Planning Commission Communication

Department: Community Development CASE #PI-24-001(M) Applicant/Property Owner: EDC Omaha Landco LLC 30 Old Kings Highway South #1005 Darien, CT 06820 Representative: John Dolan 30 Old Kings Highway South #1005 Darien, CT 06820	Resolution No. _____	Planning Commission: 4/8/2024
Subject/Title Request: Public hearing on the request of EDC Omaha Landco LLC, represented by John Dolan, to amend the adopted planned industrial development plan for a new 'data center' on property legally described as being a parcel of land located in part of the SE ¼ of Section 21-75-43 and part of the NE ¼ of Section 28-75-43, all lying south of East Kanesville Boulevard (U.S. Highway 6), City of Council Bluffs, Pottawattamie County, Iowa. Location: Undeveloped land at the southeast corner of the intersection of College Road and East Kanesville Boulevard (U.S. Highway 6)		
Background/Discussion The Community Development Department has received a request from EDC Omaha Landco LLC, represented by John Dolan, to amend the adopted planned industrial development plan for a new 'data center' on property legally described as being a parcel of land located in part of the SE ¼ of

4 ENLARGED NORTH ELEVATION
SCALE: 1/16" = 1'-0"

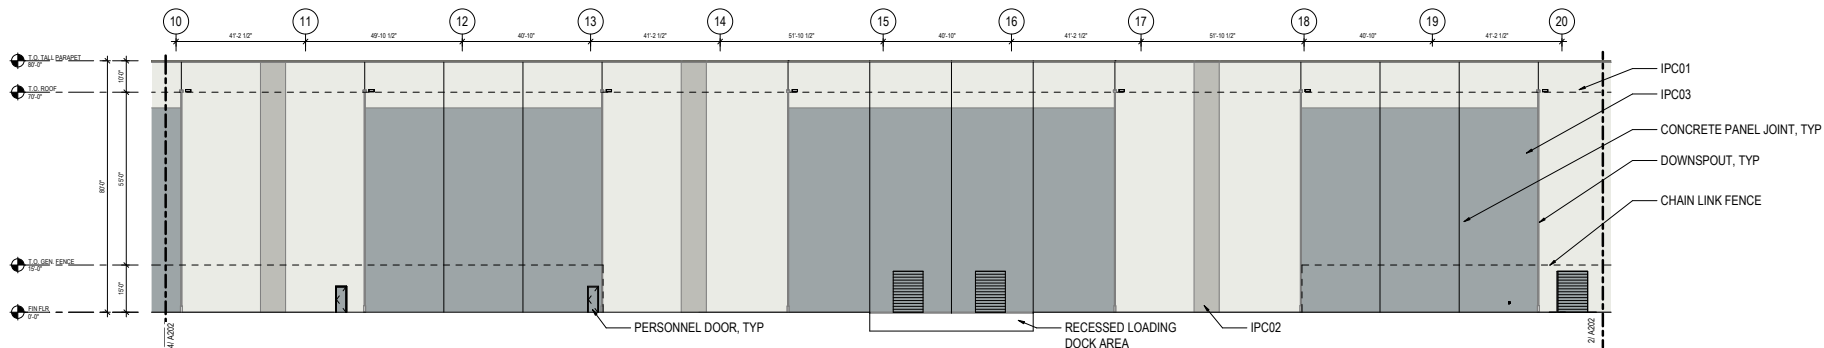
- c. The submitted site plan (Attachment 'C') shows a 35-foot tall decorative metal wall will be installed to screen the northeast corner of the north mechanical yard. A 35-foot tall decorative metal wall will also be installed to screen the southeast corner of the south mechanical yard. The proposed walls feature the use of various colors in rectangular patterns that match the design of the north elevation of the north data center building (see Sheet A200, Attachment 'C').

- a. The north elevation of the north data center building features the use of various colors in rectangular patterns to enhance the aesthetic of the proposed development as motorists enter the city from the I-80/Highway 6 interchange. This design will extend and create a continuous façade with the decorative metal wall that will screen the proposed cooling towers and water tanks from view.

PROJECT
169987
LOLA
OVERALL SITE PLAN

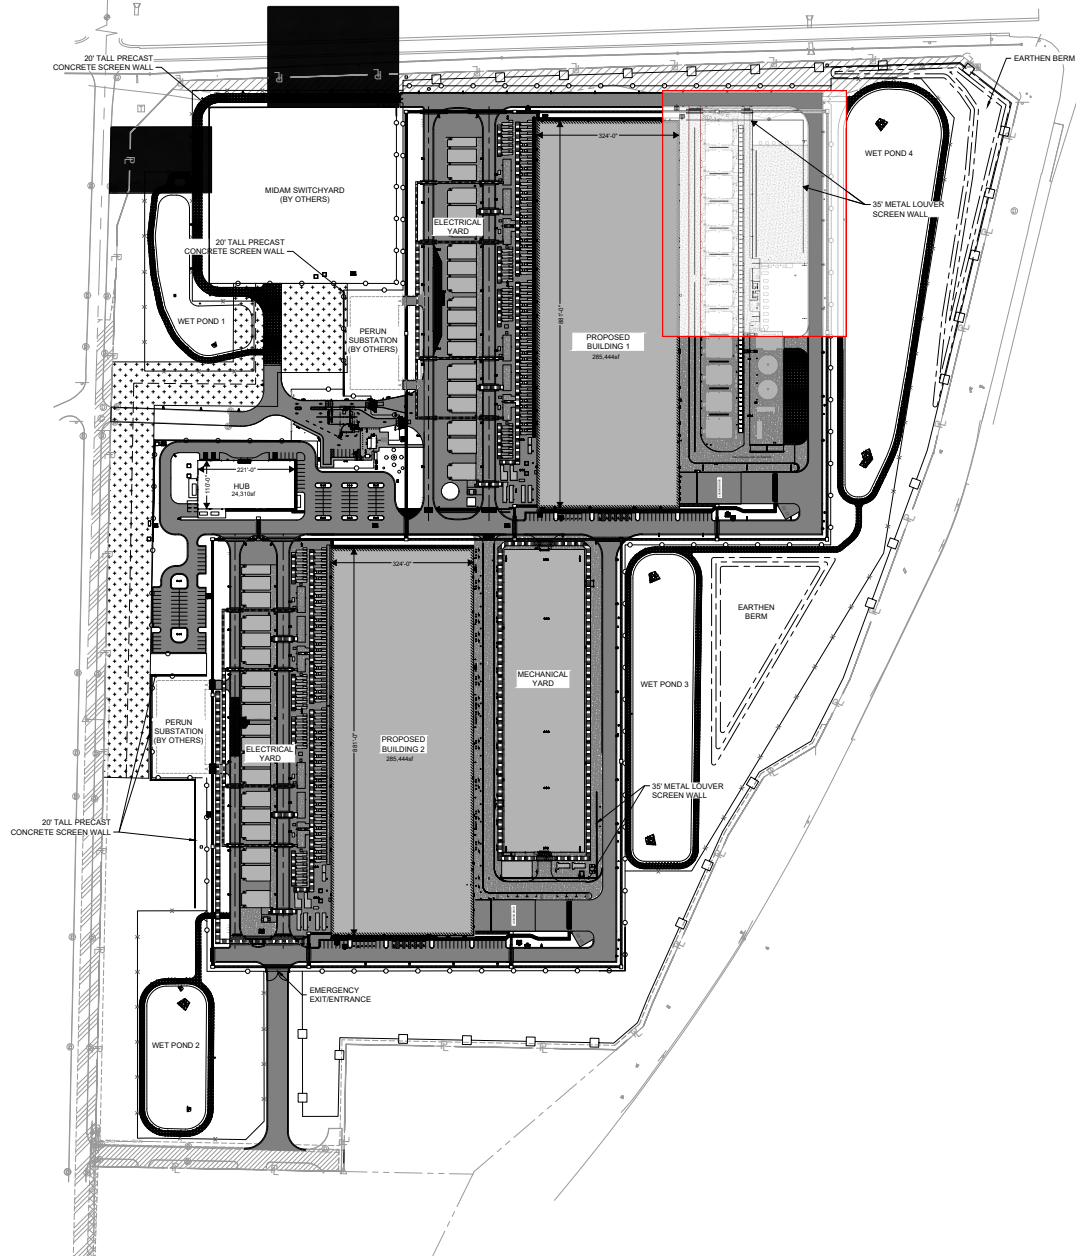
- a. The submitted site plan (Attachment 'C') shows an anti-climb Ameristar fence will be installed around the perimeter of the data center. The maximum height allowed for the proposed fence shall be 10 feet, as measured from finished grade to the highest point of the fence structure.

- b. The submitted site plan (Attachment 'C') shows a 20-foot tall masonry wall will be installed along the north and west sides of the MidAmerican Energy substation switchyard. ~~A 20-foot tall masonry wall shall also be installed~~ will extend along the northerly 20 feet of the east side of the substation in order to adequately screen all ground-mounted equipment from public view. The two owner-operated substations that will service the proposed data center will also be partially screened from view along College Road using a 20-foot tall masonry wall.

Original building elevations

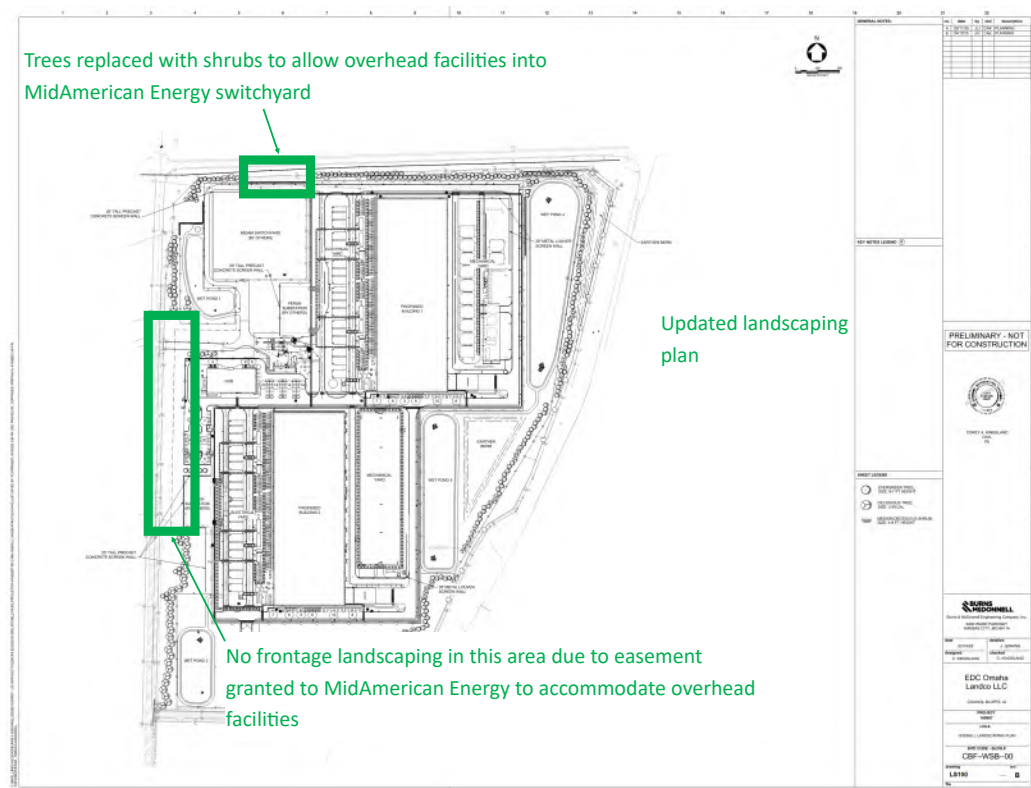
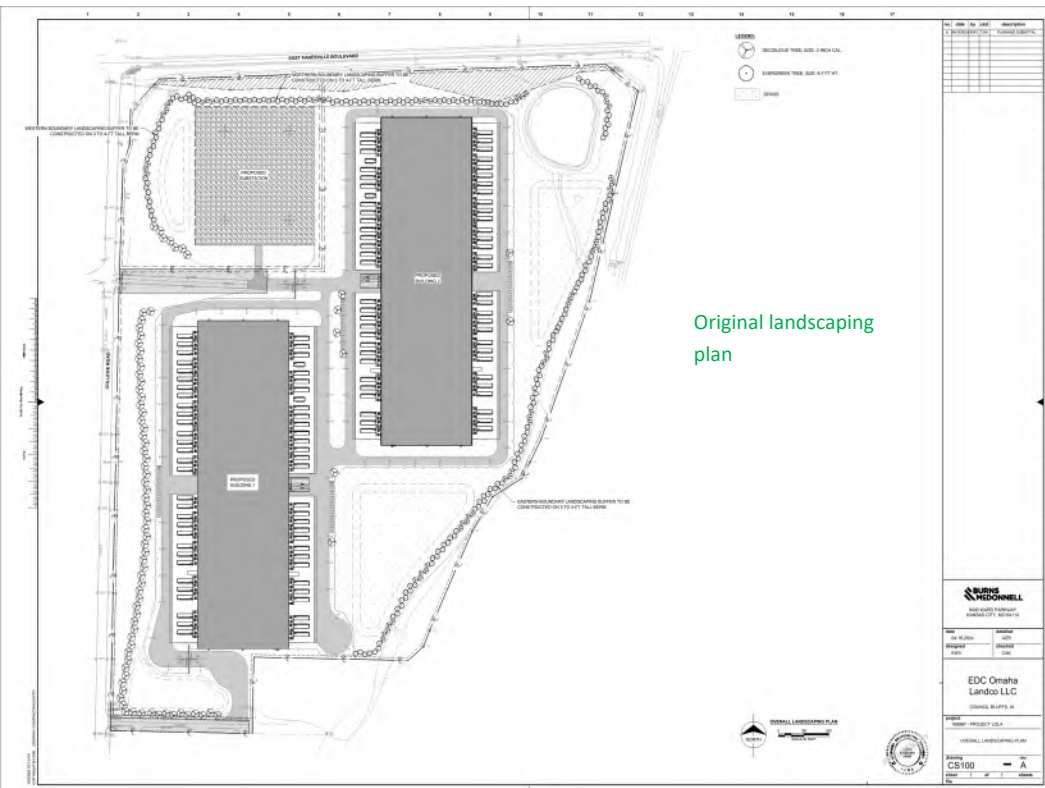
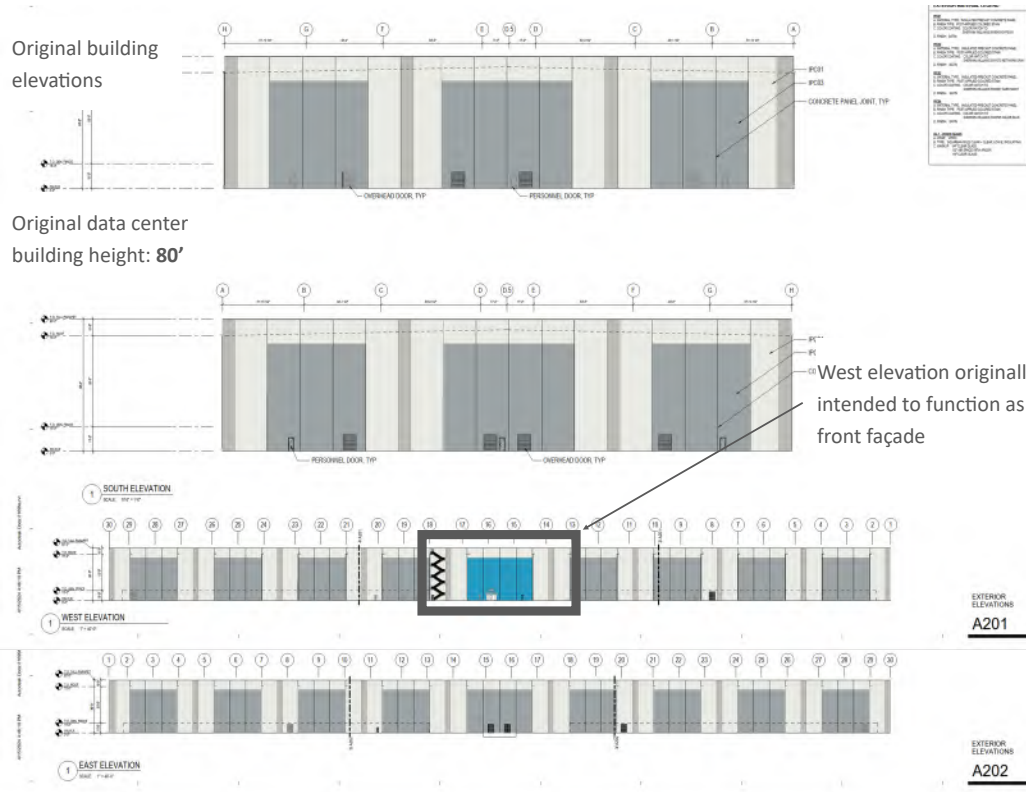
Original data center building height: 80'

New data center building height: 36'-3"

South elevation will function as front façade

North elevation will incorporate enhanced design

35-foot tall metal wall to screen cooling towers
